File FPP-1995-156
 Date 1/4/99

Project Name: NIGARA VILLAGE FILING #1

TITLE HEADING: Final Plan/Plat - Niagara Village,
Filing #1

Re: **Niagara Village Filing No. One, Response To Review Comments, File #FPP-95-156.**

GRADING & DRAINAGE PLAN NIAGARA VILLAGE SUBDIVISION	
	LANDesign ENGINEERS - SURVEYORS - PLANNERS 1000 W. 10TH AVENUE, SUITE 100, DENVER, CO 80202	
	PROJECT NO. 8084 DATE: AUGUST, 1995	SHEET NO. 1 OF 1

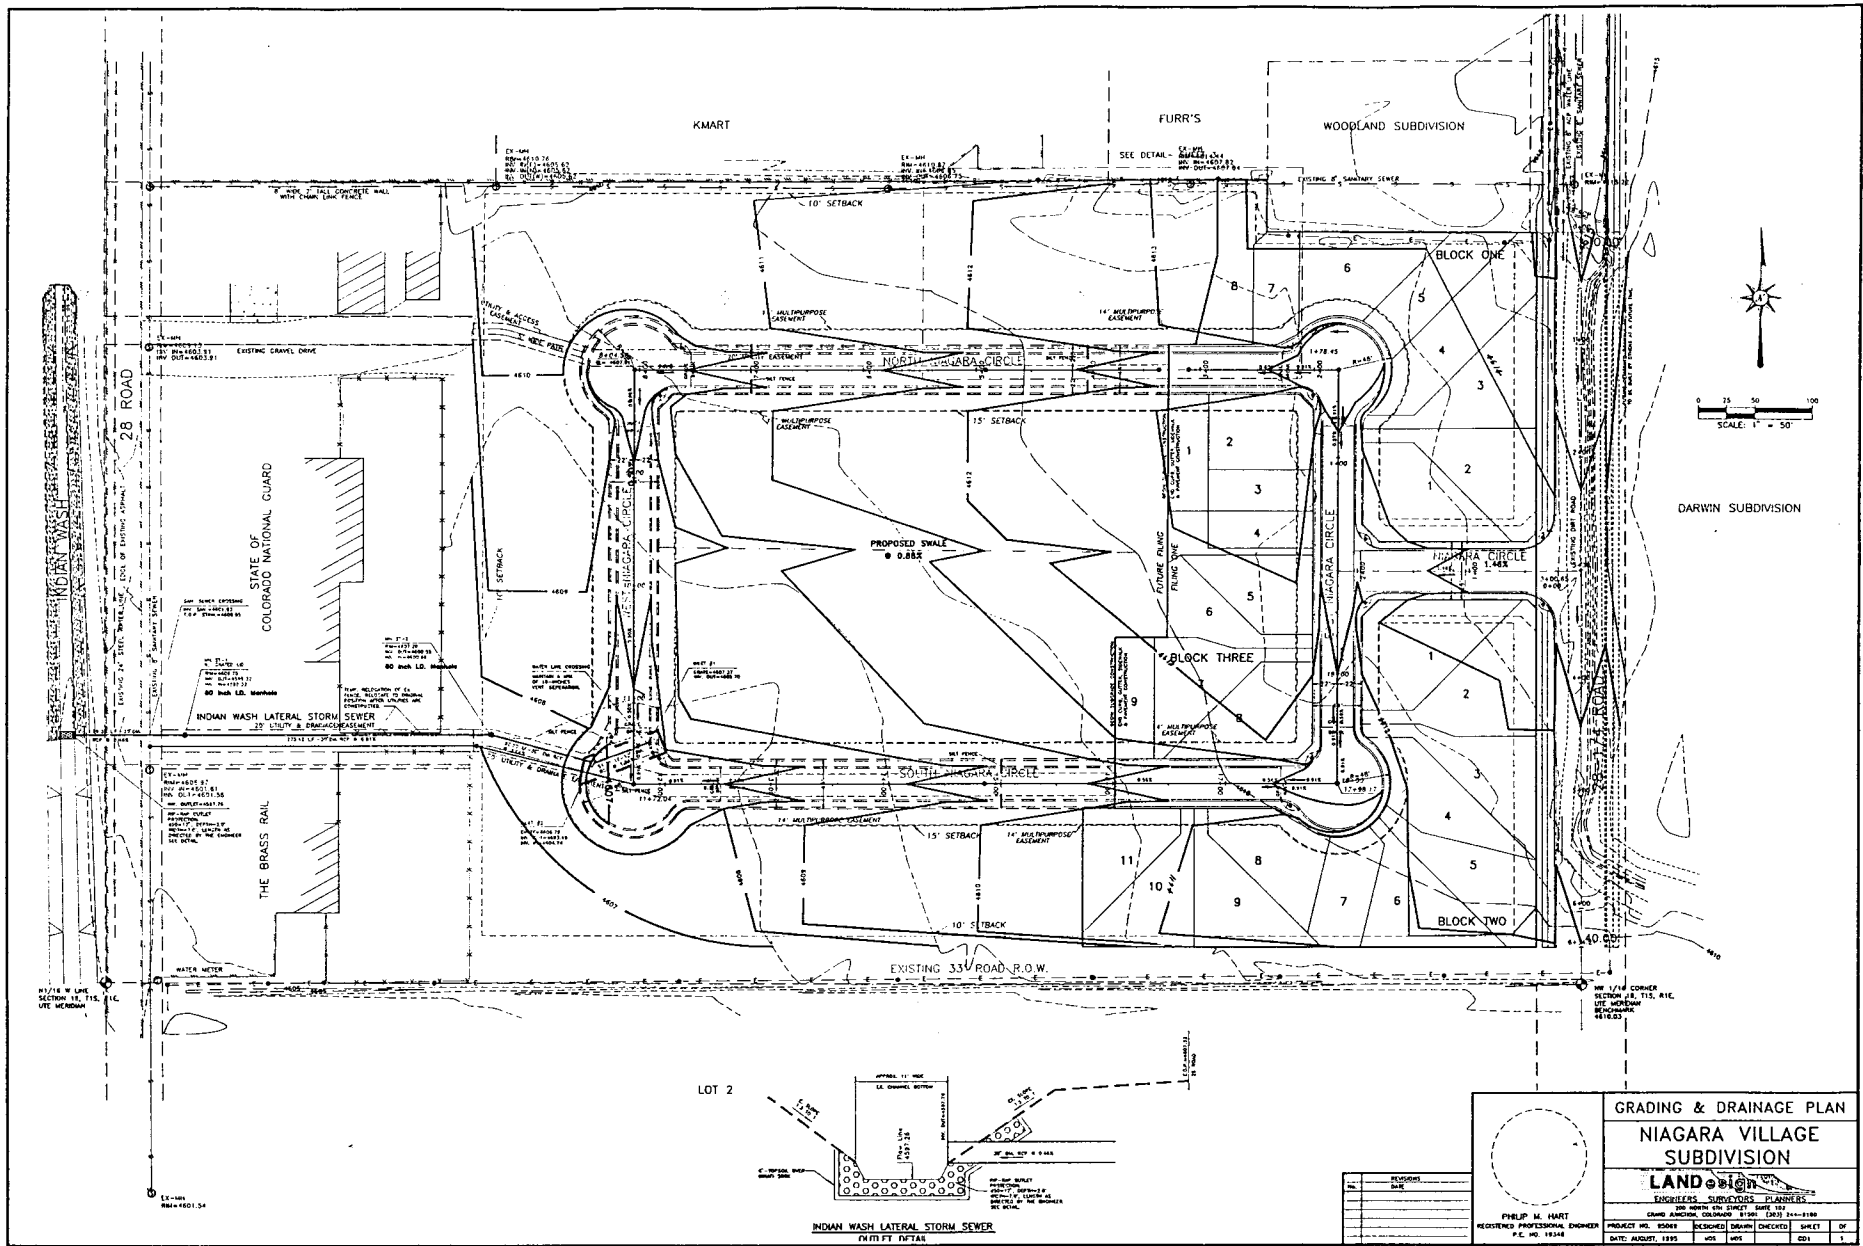
Sheet GD-2 calls out a detail for the riprap outlet in Indian Wash, but no detail is provided.

The pipe for the Goodwill Drain is noted on this sheet as CMP, however, RCP is called out in the Master Drainage Report. CMP is not approved for storm sewer under City Streets, and this will eventually be beneath 28 1/4 Road.

Sheet GD-1 also calls out a detail for the riprap and none is shown.

Please clarify how the drainage from this filing will be conveyed to the storm sewer which is apparently be be constructed with this filing. Is the grading as shown on this drawing to be done now as shown? If not, please provide a drawing which depicts what will be constructed.

1. Sheet GD-2, the "Indian Wash Lateral Storm Sewer Outfall Detail" is shown on Sheet GD-1.
2. All designations for storm sewer pipe have been revised to read "RCP".

3. Sheet GD-1, the note indicating rip-rap has been revised to say "see outfall detail, this sheet". The detail is located at the bottom center of the sheet.

STREET PLAN	
	NIAGRA VILLAGE	
	SUBDIVISION	
	LAND ENGINEERS SURVEYORS PLANNERS	
PHILIP M. HART REGISTERED PROFESSIONAL ENGINEER P.E. NO. 10348	PROJECT NO. 9004 DATE: AUGUST, 1993	SHEET NO. 010001 SHEET 3 OF 3

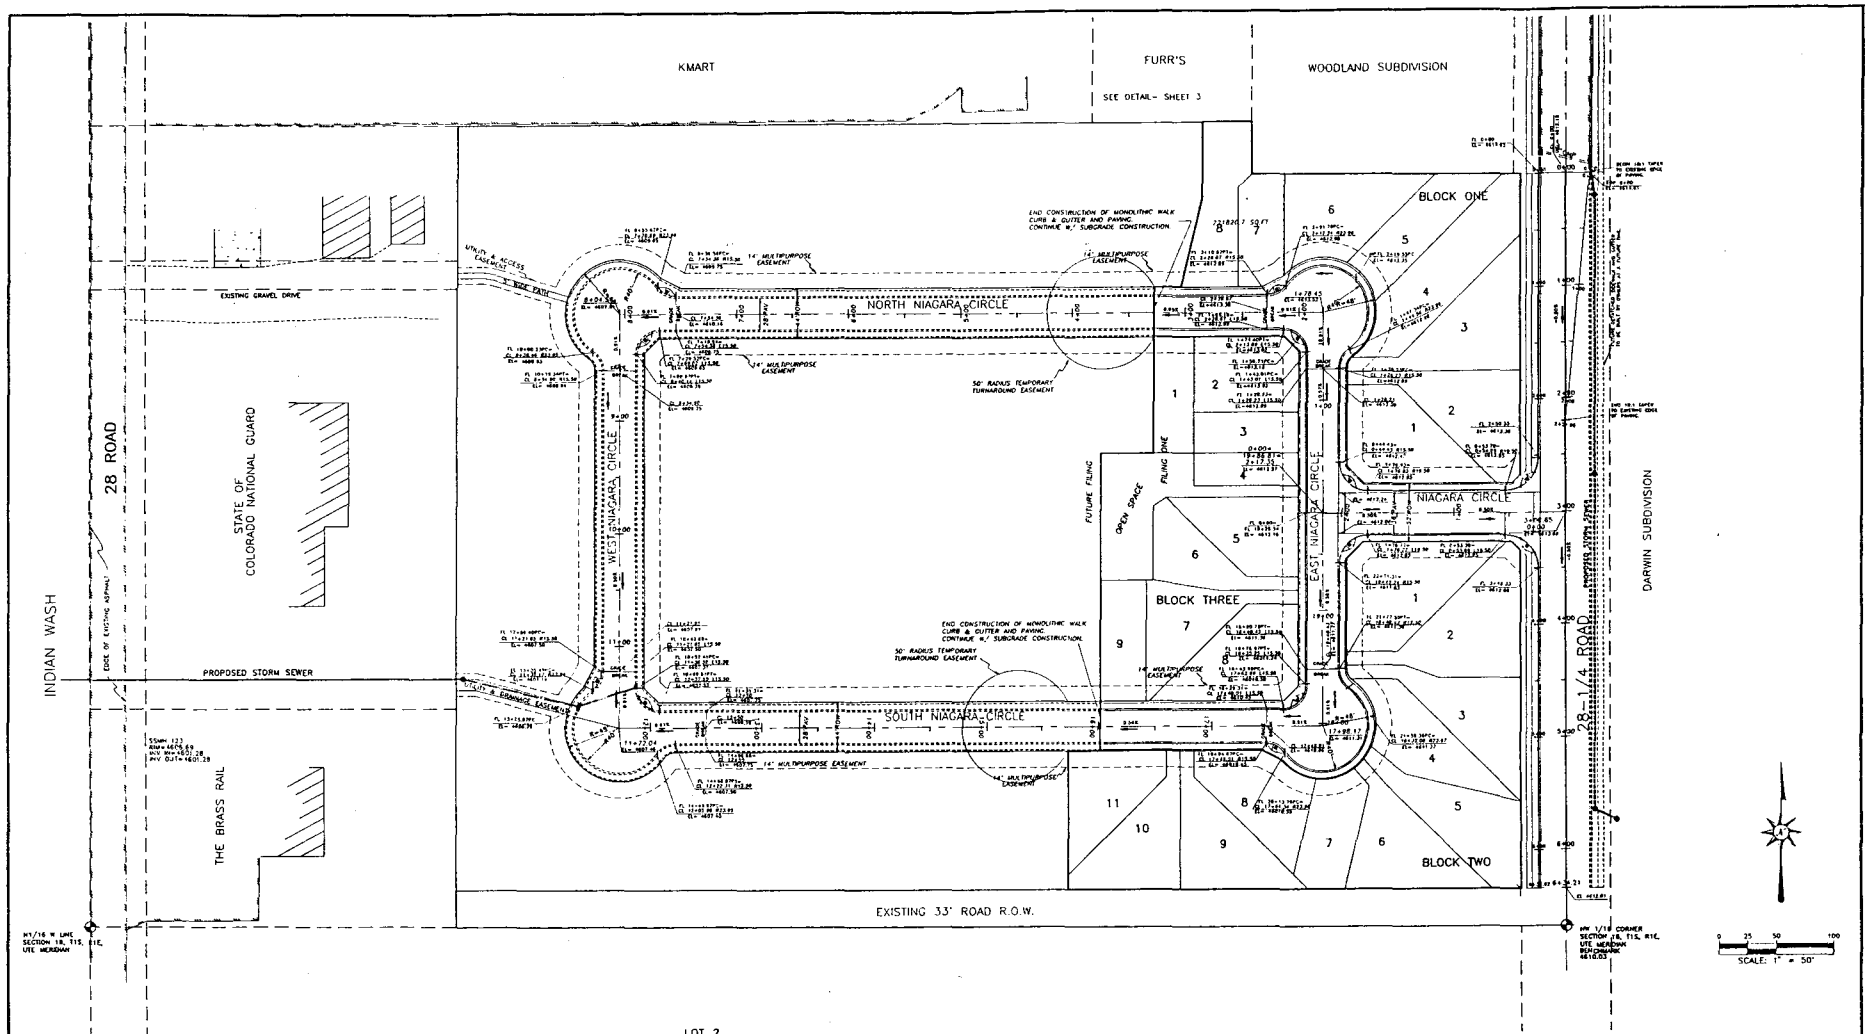
On sheet ST-1 the portion of the street which is apparently not being constructed shows a dimension of 22' of pavement. This is not correct and should be removed.

On sheet ST-2, please do not show anything beyond what is to be constructed with this filing. Please correct the spelling errors of Niagara on the profiles.

On the upper righthand side of the sheet, the profile labeled "Edge of Paveing Taper" has paving spelled incorrectly. It should also be labeled 28 1/4 Road for clarity.

On sheet ST-3, please show on the drawing only what is to be constructed. No soils report was submitted with this application and one is required. The report is needed for verification of the proposed pavement structural sections. If any change is required to these sections, it will also affect the quantities shown in the improvements agreement.

2. Sheet ST-1, the dimension of 22-feet has been revised to read.
3. Sheet ST-2, curb, gutter and side walk to be constructed with future phases are shown as dashed. The spelling errors have been corrected.

4. Sheet ST-2, the spelling error in the profile for the edge of paving taper has been corrected. The title of the profile has been revised designate 28 1/4 Road.

5. A phase line and note have been added which identifies the limits of construction for roadway improvements. A soils investigation has been performed by Lincoln DeVore Geotechnical Consultants as well as a structural pavement design. A copy of their recommendations are attached. The improvements agreement will be revised to reflect actual bid quantities and prices for the asphalt section as designed by Lincoln DeVore. The agreement shall be submitted prior to the City's approval to begin construction.
